**SUBJECT: THREE MILE ISLAND, UNIT 1 (TMI UNIT 1)
OPERATING LICENSE NO. DPR-50
DOCKET NO. 50-289
LICENSE AMENDMENT REQUEST NO. 308, TRANSMITTAL OF
CAMERA-READY TECHNICAL SPECIFICATION PAGES**

**Operating License No. DPR-50
Docket No. 50-289
License Amendment Request No. 308
Transmittal of Camera-Ready Technical Specification Pages**

TMI Unit 1 Technical Specification Revised Pages for

(Pages ii, vii, 3-3, 3-4, 3-5, 3-5a, 3-5b, 3-18d, 3-18e, 3-18f, and 4-41)

Figure 3.1-1 Reactor Coolant System Heatup/Cooldown Limitations [Applicable through 29 EFY]

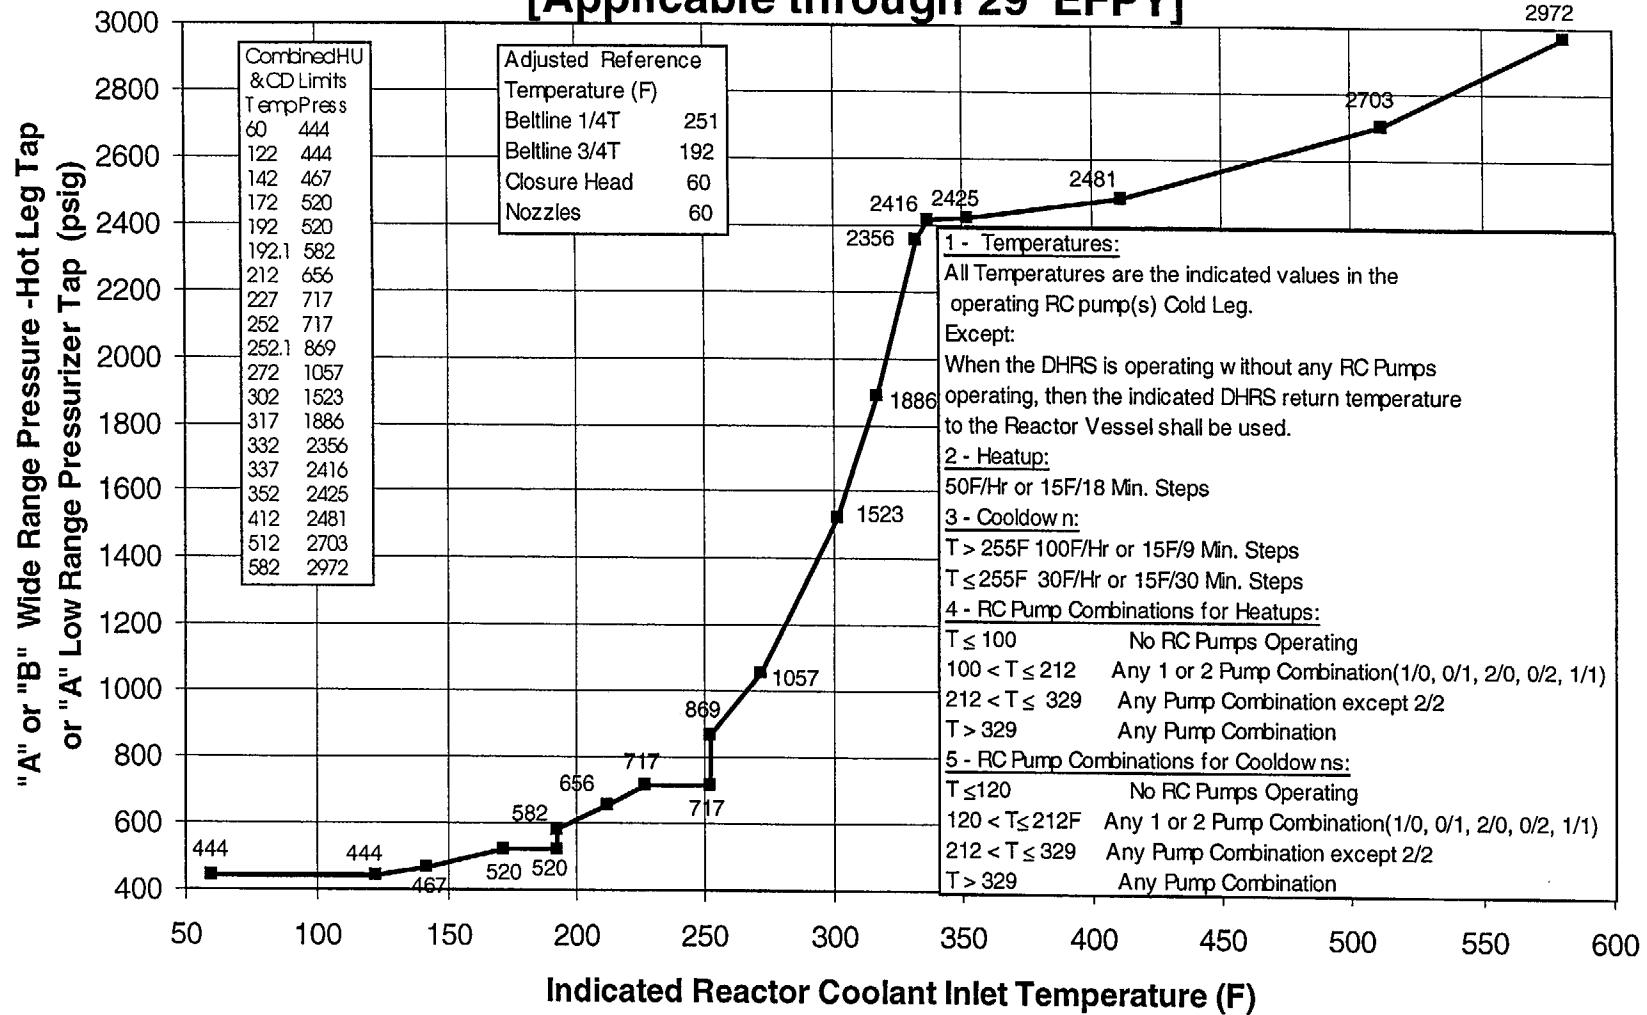
- 3.1.2.1 For operations until 29 effective full power years, the reactor coolant pressure and the system heatup and cooldown rates (with the exception of the pressurizer) shall be limited in accordance with Figure 3.1-1 and Figure 3.1-2 and are as follows:

Allowable combinations of pressure and temperature shall be to the right of and below the limit line in Figure 3.1-1. Heatup and cooldown rates shall not exceed those shown on Figure 3.1-1.

- 3.1.2.4 Prior to exceeding 29 effective full power years of operation, Figures 3.1-1 and 3.1-2 shall be updated for the next service period in accordance with 10 CFR 50, Appendix G. The highest predicted adjusted reference temperature of all the beltline materials shall be used to determine the adjusted reference temperature at the end of the service period. The basis for this prediction shall be submitted for NRC staff review in accordance with Specification 3.1.2.5.

Based on the predicted RT_{NDT} after 29 effective full power years of operation, the pressure/temperature limits of Figure 3.1-1 and 3.1-2 have been established by FTI calculation, Reference No. 7, in accordance with the requirements of 10 CFR 50, Appendix G. Also, see Reference 4. The methods and criteria employed to establish the operating pressure and temperature limits are as described in BAW-10046A, Rev. 2 and ASME Code Section XI, Appendix G, as modified by ASME Code Case N-640 and N-588. The protection against nonductile failure is provided by maintaining the coolant pressure below the upper limits of these pressure temperature limit curves.

Figure 3.1-2 Reactor Coolant Inservice Leak Hydrostatic Test [Applicable through 29 EFPY]

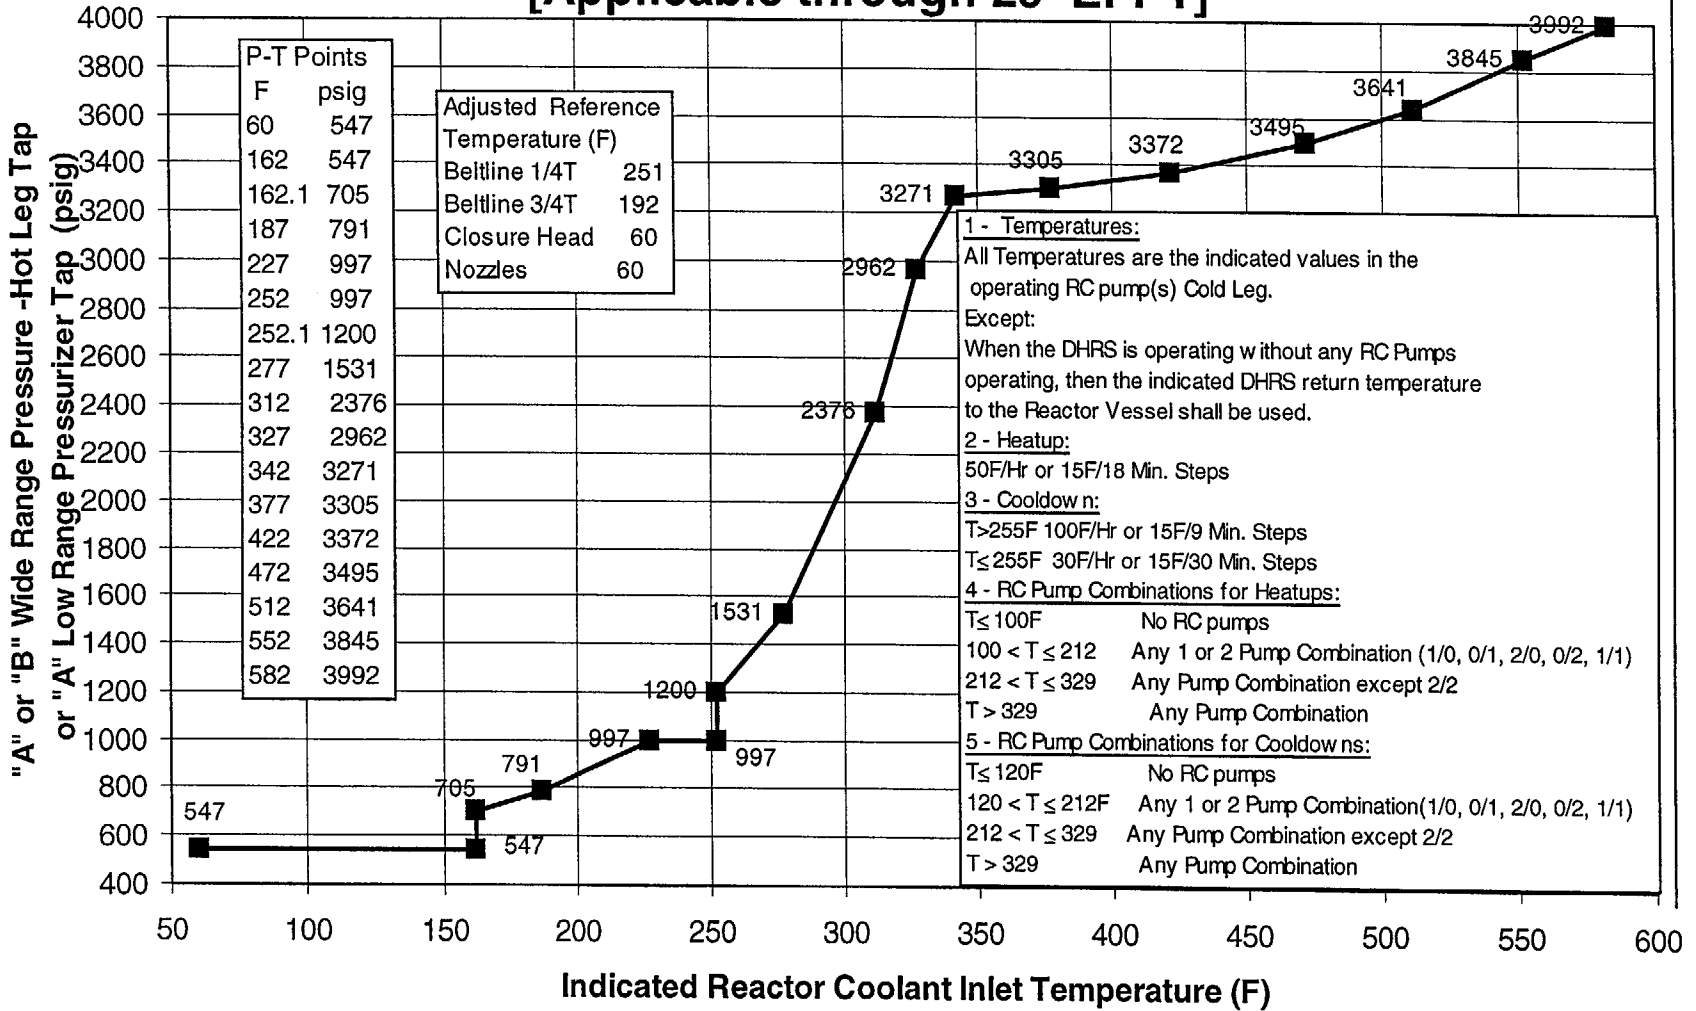
Allowable combinations of pressure and temperature shall be to the right of and below the limit line in Figure 3.1-2. Heatup and cooldown rates shall not exceed those shown on Figure 3.1-2.
